# **County of Loudoun**

SUBJECT: ZMOD 2008-0009, Lansdowne Village Greens Sign Plan -

**Second Referral**

# LANSDOWNE VILLAGE GREENS TOWN CENTER - PHASE 2 COMPREHENSIVE SIGN PLAN

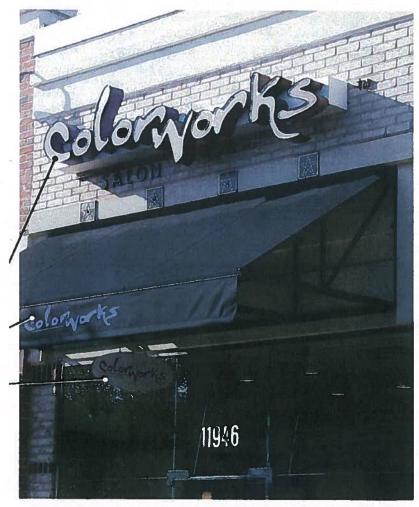
Zoning Administration staff has determined that sign type P2 cannot contain advertising and therefore will need to remove tenant names. Staff concurs that directional signs should be for wayfinding purposes only and should not provide individual tenant information. Staff also agrees with Zoning Administration that the size and scale of this signage should be reduced in keeping with the pedestrian nature of the development. Zoning Administration staff has also determined that sign type P3 is not a permitted sign type and will need to be removed from the sign plan; therefore, staff has not provided any comments regarding the pedestrian directories (see Zoning Administration first and second referrals).

Staff recommends the applicant remove tenant names from site directional signs (sign type P2) as these signs should be for wayfinding purposes only. Staff further recommends reducing the size and scale of sign type P2 in keeping with the pedestrian scale of the town center. Sign type P3 should be removed from the sign plan (see Zoning Administration first and second referrals).
